Land at Hartnolls Farm, Tiverton

Proof of Evidence of Neil Thorne
BSc (Hons) MSc MCIHT MTPS

Covering Highways and Transportation Matters

Planning Inspectorate Reference – APP/Y11138/W/3313401

Figure 3.1 Future Predicted Traffic Flows at Westcountry Land Proposed Junction

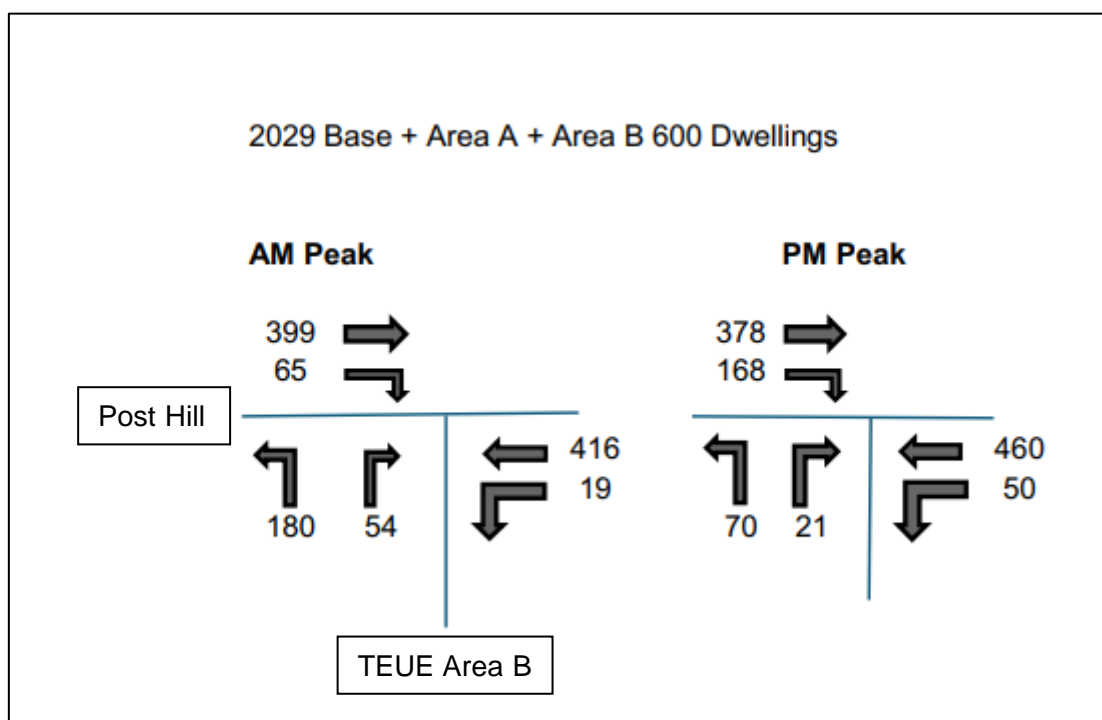
- 3.25 In the future, with Area A fully occupied, the two-way flows on Post Hill are predicted to increase to 815 (399 + 416) and 838 (378 + 460) vehicles during the AM and PM peak hours, respectively. As shown in Figure 3.1, these Post Hill movements are by far the highest flows at the junction in both peak periods.

- 3.26 This demonstrates that the significant majority of traffic will in future continue to travel east-west along Post Hill, to and from Tiverton, consistent with the established hierarchy as set out within the Adopted SPD and Area B Masterplan.

- 3.27 In contrast, the predicted two-way flows along the Westcountry Land proposed main road with changed priority (TEUE Area B to Post Hill East), would be 73 (54 + 19) and 71 (21 + 50) during the AM and PM peak hours, respectively.

- 3.28 The proposed arrangement would therefore force the dominant east-west movement to give way to vehicles accessing the Westcountry Land site along their proposed main road.

Figure 3.2 Deflection for Vehicles Travelling West on Post Hill

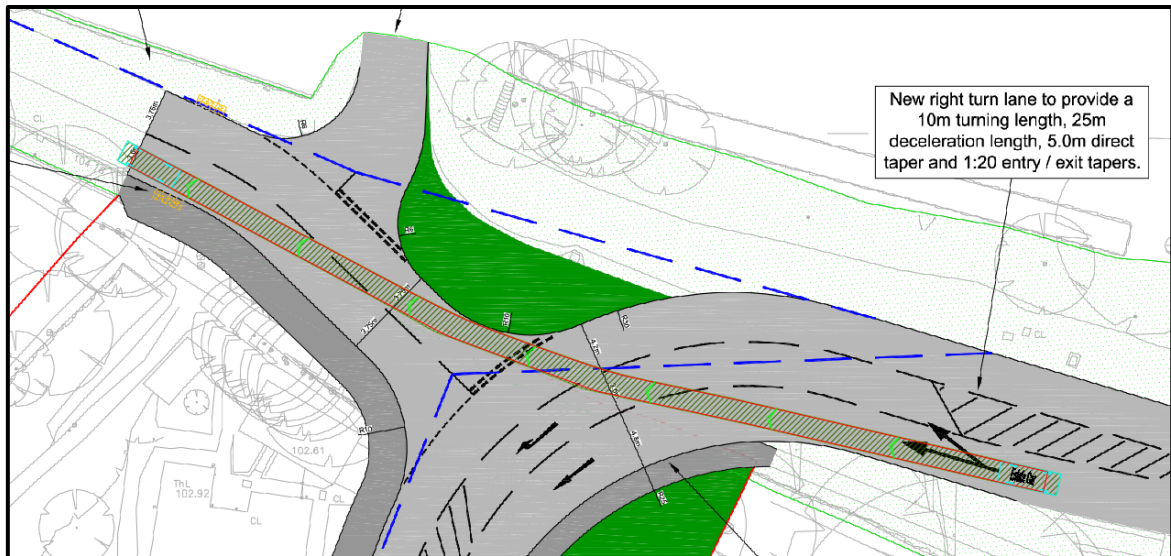
3.40 To demonstrate this failing with the Westcountry Land proposed scheme, while a vehicle turning right from a major road to a minor road would typically be required to complete a 90-degree turn, a vehicle travelling west along Post Hill could complete a ‘right turn’ movement (westbound from Post Hill major road to Post Hill minor road) with little to no deflection. This movement is shown by **Figure 3.2**.

3.41 The DMRB design guidance ‘CD116 Geometric design of roundabouts’ states that deflection is a key safety concern for when vehicles are required to give-way. This document states at paragraph 3.2.1 that:

3.43 Whilst this guidance relates specifically to roundabouts, the same principles also apply to other junction types. It is not specifically set out in CD 123 as the Para 2.1 requirement (as stated above – i.e. avoiding priority junctions on sharp bends) would inherently create this necessary deflection. It should be noted that it is a mandatory requirement to provide appropriate deflection on approach roads to roundabouts, due to the significant impact which deflection has on safety.

Figure 3.3 Forward Visibility Splay for Vehicles Travelling West on Post Hill

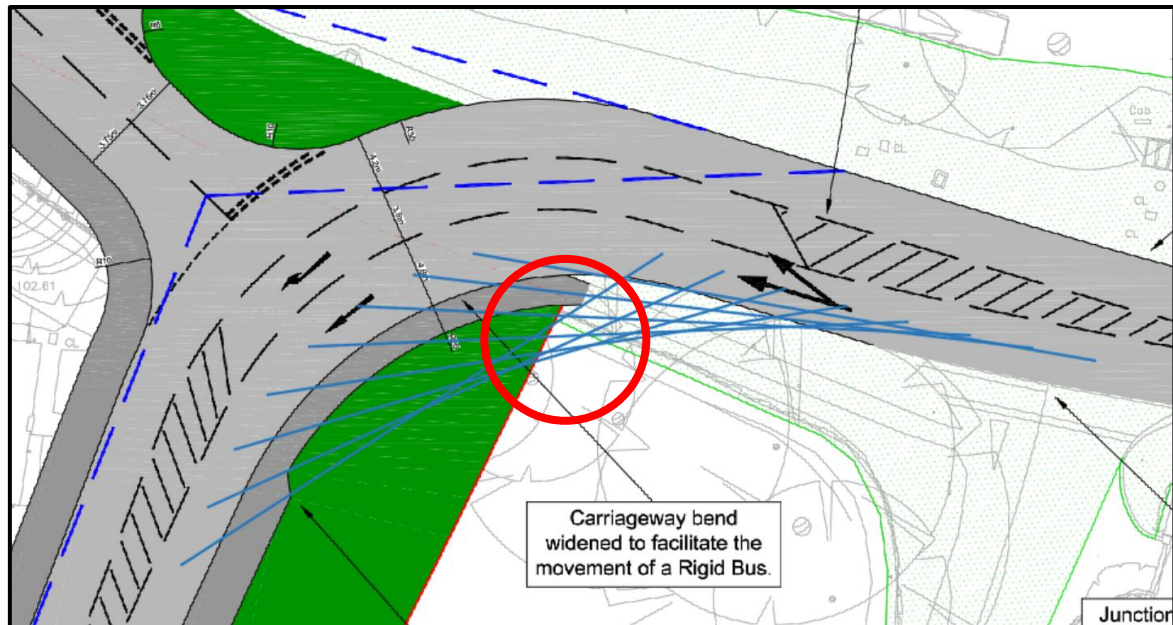
- 3.54 Forward visibility is the distance a driver needs to see ahead to stop safely to avoid an obstruction in the road at a given speed. The required forward visibility splay for a 40mph design speed would be 120m, as per DMRB guidance. The required visibility splay for a 30mph design speed would be 43m as per MfS guidance. Neither of these forward visibility splays are achievable.
- 3.55 The 43m forward visibility splay is shown (in blue) in **Figure 3.3**.

3.56 The 43m (30mph) visibility splay is unachievable without crossing third party land. Figure 3.3 shows these visibility splays extending outside of the adopted highway (light green shaded area, edged green) and that owned / optioned by Westcountry Land (dark green shaded area, edged red), which means that the proposed junction design does not meet either DMRB or MfS standards. I have identified the area in question within the red circle.

3.57 The maximum forward visibility achievable is approximately 34m, which corresponds with a design speed of approximately 25-26mph, in accordance with MfS. This is lower than the required forward visibility for a 30mph design speed (43m) and substantially lower than the required forward visibility for a 40mph design speed (120m).

3.58 The lack of appropriate forward visibility increases the risk of westbound vehicles colliding with other road users, including pedestrians, or objects in the carriageway.

Figure 3.4 Junction Visibility Splay for Vehicles Emerging from Manley Lane

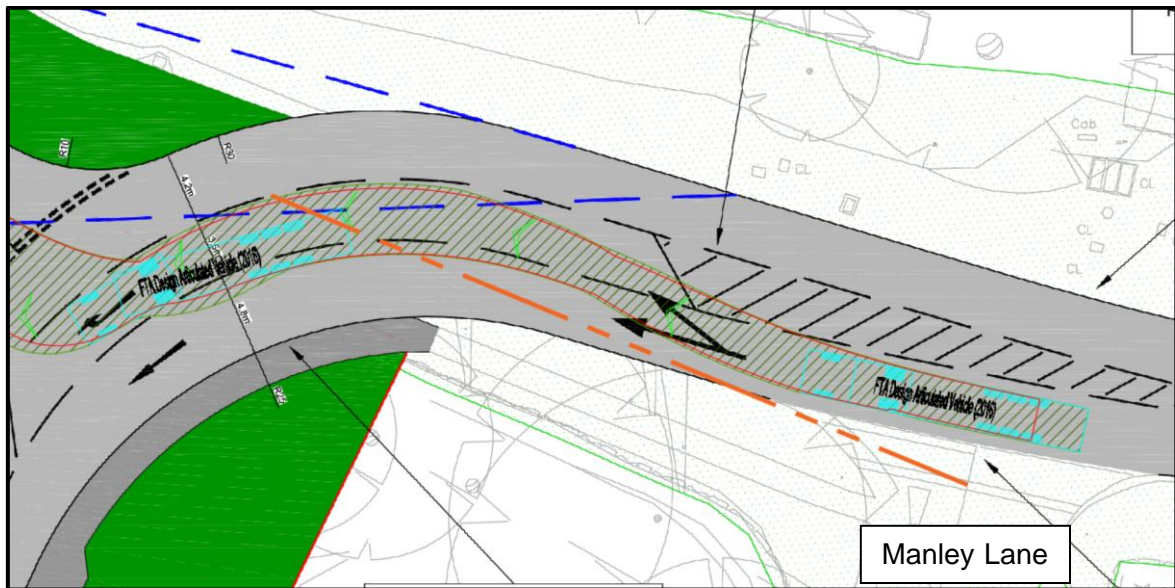
3.59 The Westcountry Land drawing does not show junction visibility splays from Manley Lane.

3.60 The 43m (30mph design speed) visibility splay from Manley Lane would cross the right turn lane and would be obscured by vehicles waiting in the right turn lane. This is shown (in orange) in **Figure 3.4**.

3.62 The proposed priority junction would encroach on the visibility of Manley Lane which is contrary to DMRB standards. This could increase the chance of collisions for vehicles emerging from Manley Lane.

Figure 3.5 FTA Design Articulated Vehicle Swept Paths

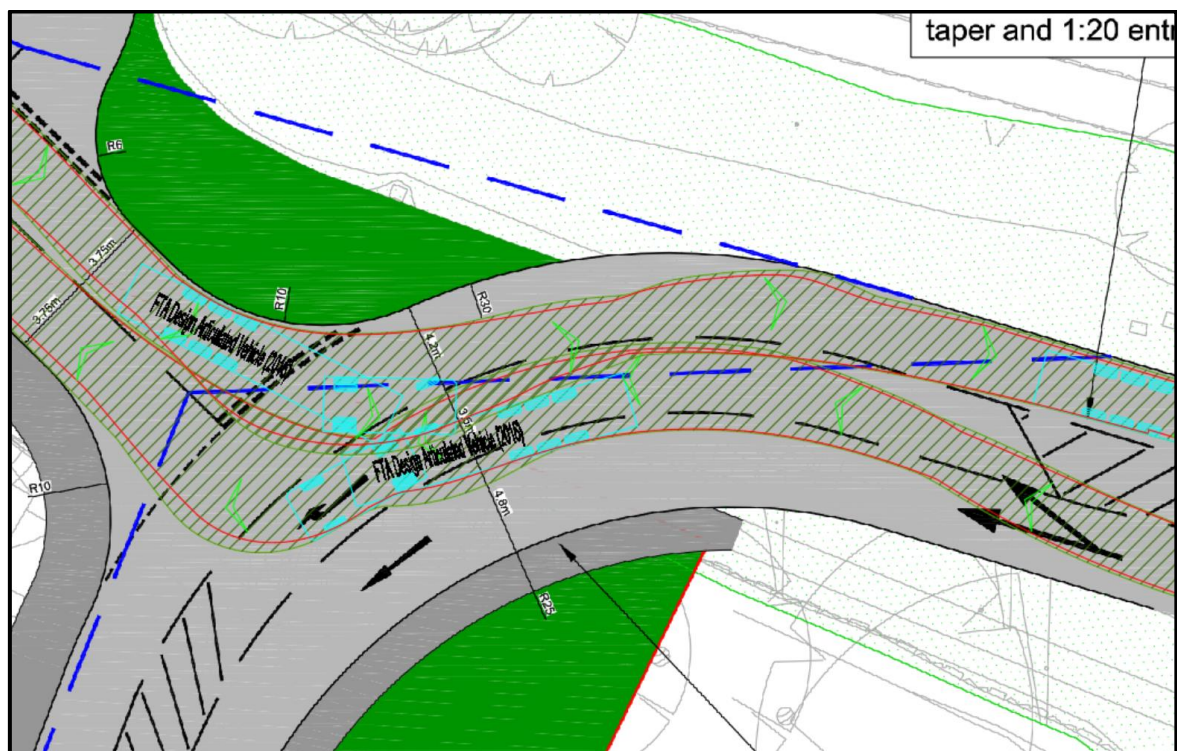
- 3.63 On site observations reveal that a significant number of HGVs, buses and LGVs pass along Post Hill. At the location of the proposed junction these east-west movements are currently made simultaneously without conflict.
- 3.64 If the proposed junction were introduced these movements would not be able to be made simultaneously, with large vehicles being required to give-way to one another on approach to the junction. Both eastbound and westbound HGVs would also encroach on neighbouring lanes. These safety concerns and vehicular conflicts are shown by **Figure 3.5**.

- 3.65 The introduction of conflict where there is currently none creates delay and increases the risk of collisions. If a large vehicle is required to wait on approach to the junction to allow an opposing large vehicle to navigate the junction, this also increases the risk of rear-end shunts.

Figure 3.6 Assumed Pedestrian Crossing Point Visibility

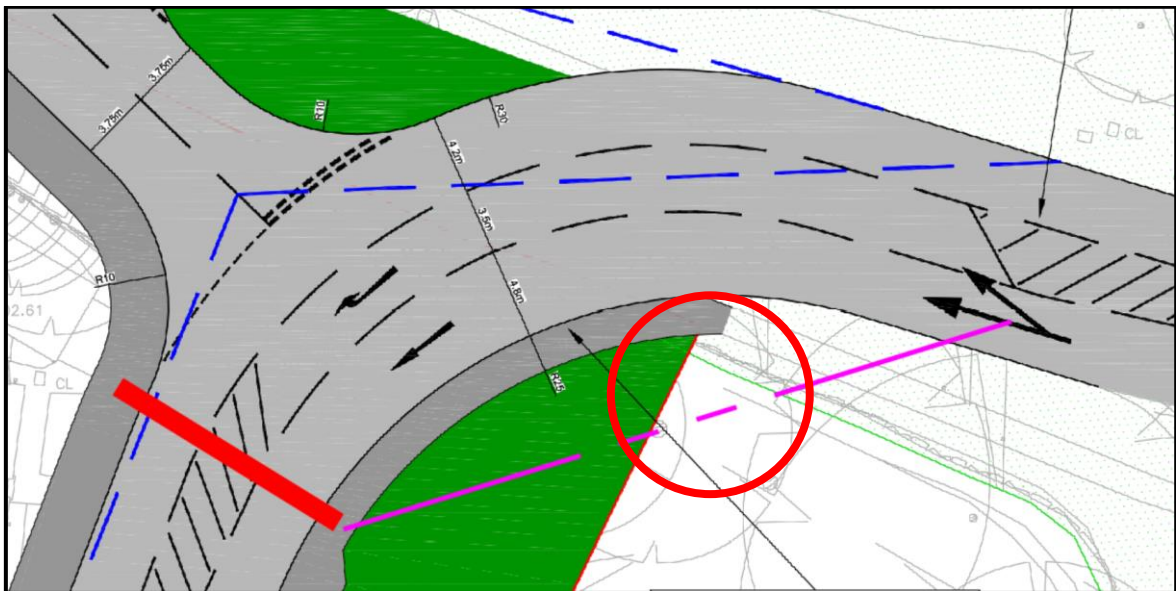
- 3.66 There is an existing footway on the south side of Post Hill which provides pedestrian access to the residential properties accessed from Manley Lane. The grass verge on the south side of Post Hill east of this point is also used to provide pedestrian access to Hartnoll Business Centre.
- 3.67 This established pedestrian route / desire line is not accommodated by the proposed junction arrangement drawing, which does not show any pedestrian crossing facilities.
- 3.68 It is assumed that pedestrians would be required to cross at the position which I have marked with a red line below in **Figure 3.6**, while the magenta line represents a 1.5m x 43m pedestrian visibility splay from the eastern side of the crossing point.

- 3.69 As with the forward visibility explained earlier, pedestrians crossing in this location would not be able to see oncoming vehicles at 43m (30mph design speed) distance, let alone 120m (40mph existing speed). In turn, oncoming vehicles would not be able to see a pedestrian waiting to cross. This means that vehicles travelling west along Post Hill, approaching the crossing point, would not be visible to pedestrians as they begin to cross and vice versa.
- 3.70 The introduction of this proposed junction arrangement would effectively sever an existing pedestrian route. This arrangement introduces the risk of vehicle to pedestrian collisions and is fundamentally unsafe.

Figure 3.7: Required Increased Length of Right Turn Facility

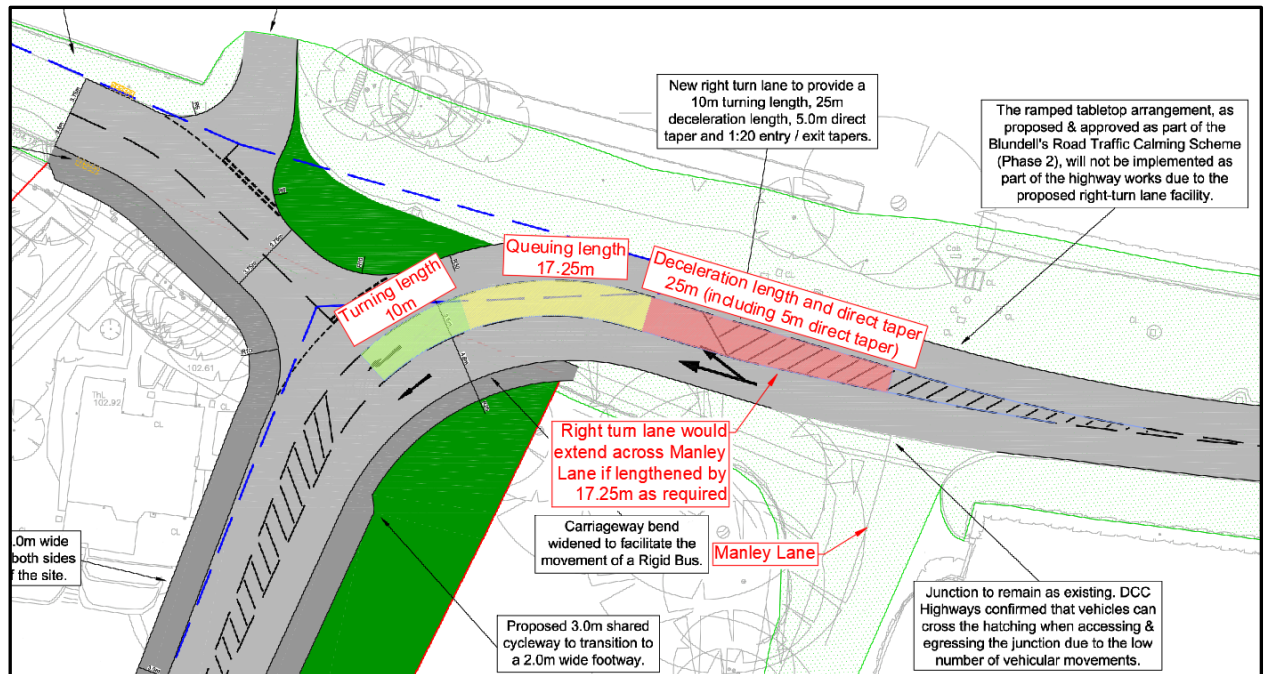
3.94 The designers have failed to account for this additional queue length when designing the junction, and is therefore not in accordance with design standards. The right turn facility within the junction should therefore be increased by 17.25m (taken, conservatively, from the forecast mean maximum queue length).

3.95 This would extend the length of the right turn lane back across the Manley Lane junction, meaning vehicles exiting Manley Lane may be blocked by vehicles manoeuvring or queuing within this designated lane, and results in yet a further safety concern. This is demonstrated in **Figure 3.7**.

3.96 Furthermore, any vehicle waiting to turn right into Manley Lane is at risk of rear shunt collision due to the fact that forward visibility of north-east bound vehicles is blocked by this queuing traffic, and they may not see the stationary vehicle in time to brake.
